RELEASE NOTE SUMMARY

iBRID™ MX6

MX6 iBrid

2. New Pump Test at Startup Required in Aspirated MX6s

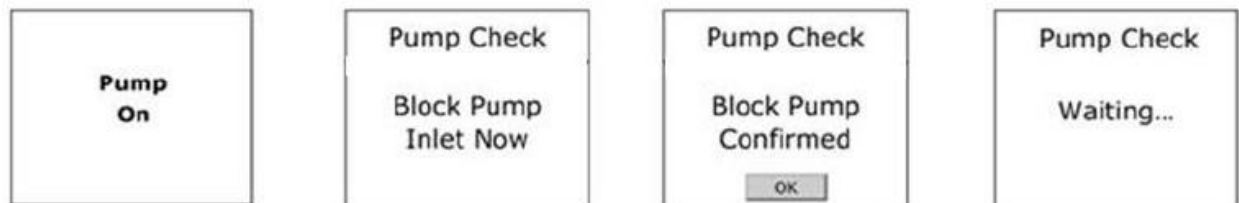
To ensure the safety of our customers, the MX6 will require users to block the pump during startup prior to advancing to the Normal Reading Screen. If the user does not acknowledge the screen prompts, the instrument will go into low alarm. This feature was added to notify customers of pump failures before entering unsafe environments, especially those working in high noise environments. This feature is disabled when connected to a docking station.
